Ardgour Rise Road Safety Review

Alternate Alignment Safety Review

Prepared for:
Santana Minerals Ltd

Project/File:
310206156

Figure 10: Example of revised design

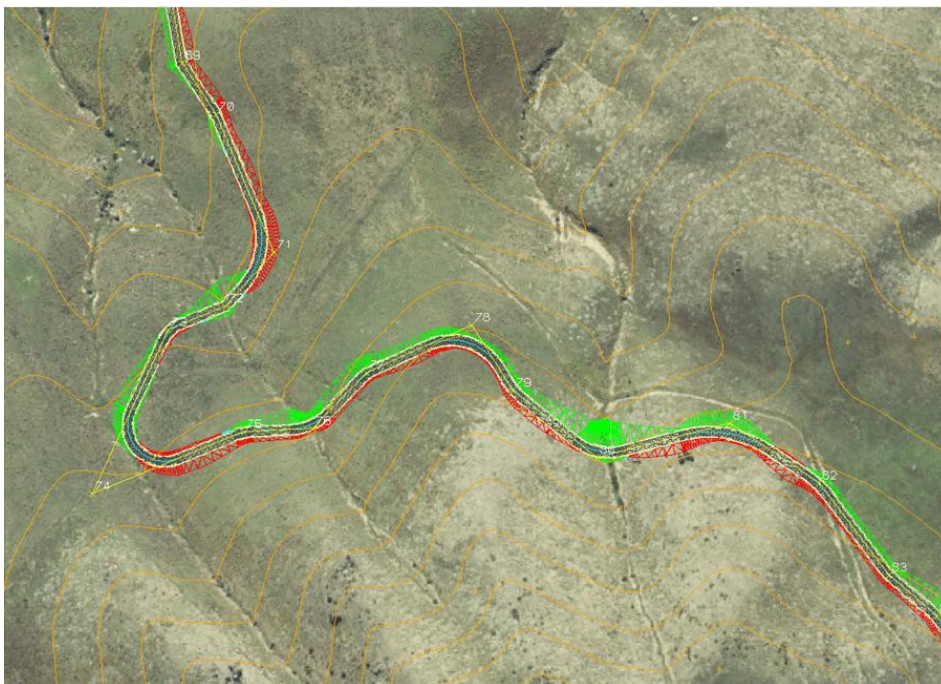
Through an analysis of the proposed design, and following observations on site, discussions were held with the project team on potential changes within the design to address the length of steep grades, with an aim to reduce the general gradient below 14%.

A revised design was submitted on Monday 27th July 2026, with further discussions with the designer that same day. This revised design revealed an alignment from CH 4880 to CH 5440 with a gradient on average of below 12.5%. This was achieved through traversing further into gullies, and a general shift utilising a longer distance for the grade change. It is considered that this style of change is demonstration that a redesign of the alignment further in detailed design would result in a more suitable gradient.

A modified design has been undertaken that results in the general elimination of grades above 13%, from CH 3960 through to above CH 8580. This is discussed further in Section 3.3 below.

Figure 11: Alignment height / Grade comparison graph.

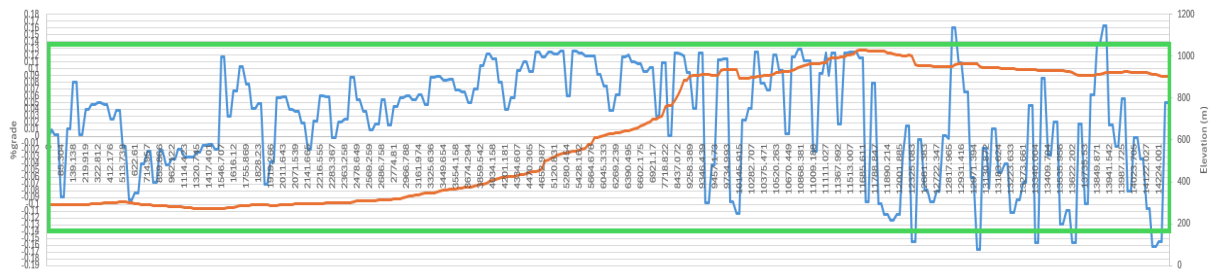
Figure 11 below details the new road profile (orange), with gradient (blue). The boundary box (green) is the bounds of 12.5% gradient. As demonstrated, there remains isolated sections of road above 12.5%, being the alignment along the highest portion of the proposed road.

Figure 12 demonstrates areas where the Revision 4 design steep grade sections (green) have been reduced, resulting in a less steep alignment in Revision 5 (orange). It is acknowledged that there are short sections of steep grade (16%) along the tops, however these are isolated in length, with recovery grades between.

Figure 13: Grade Summary Analysis

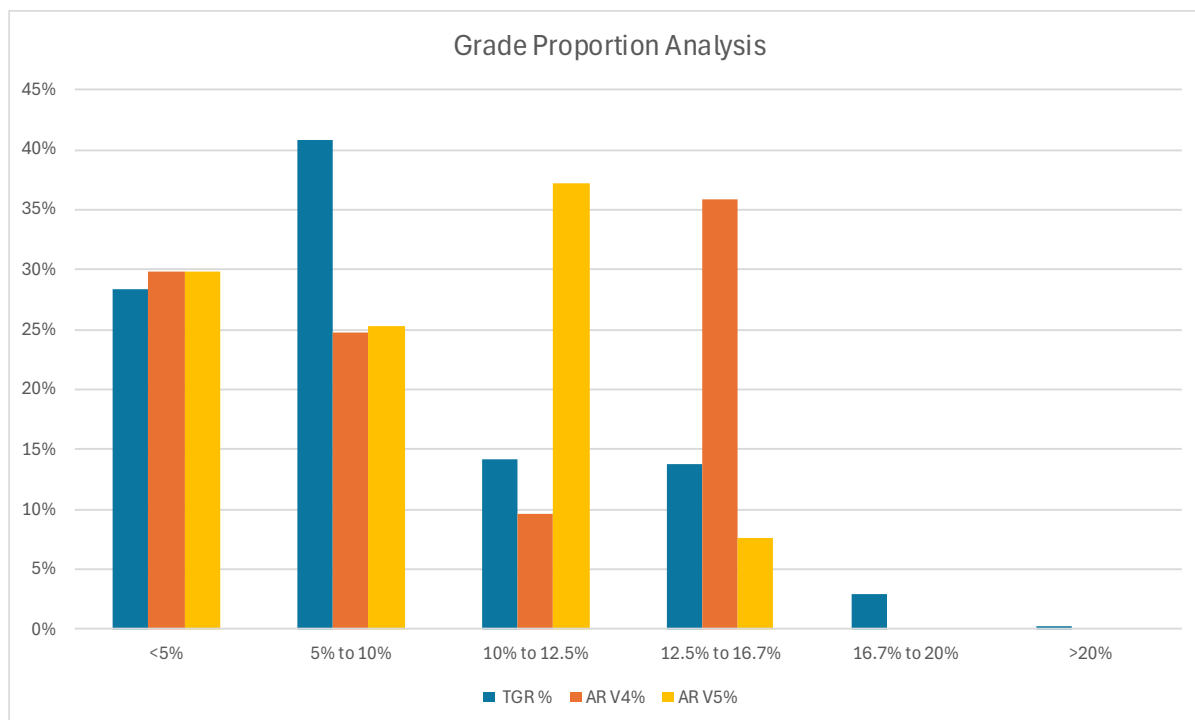
The length of both the Ardgour Rise V4 and V5 designs is 13.6 km and 14.3 km respectively. Analysis of the grade data has been undertaken from a start point at the entrance to the mine site, commencing at Thomson Gorge Road, and traversing through to rejoining Thomson Gorge Road at CH 12.1 km.

An analysis of the V4 design as submitted to the hearing had a higher proportion of grades in the 12.5% to 16.7%. The version 5 design has reduced this.

This analysis reveals that the Ardgour Rise alignment (V5) results in a lower percentage of length at the higher grades, with no grades exceeding 16.7%. This is achieved through utilising a higher proportion of mid-range grades (10 to 12.5%).

In summary, the Ardgour Rise V5 alignment generally results in a reduction of steeper grades when compared to the existing Thomson Gorge Road alignment, and is generally compliant with the ARRB guidelines.
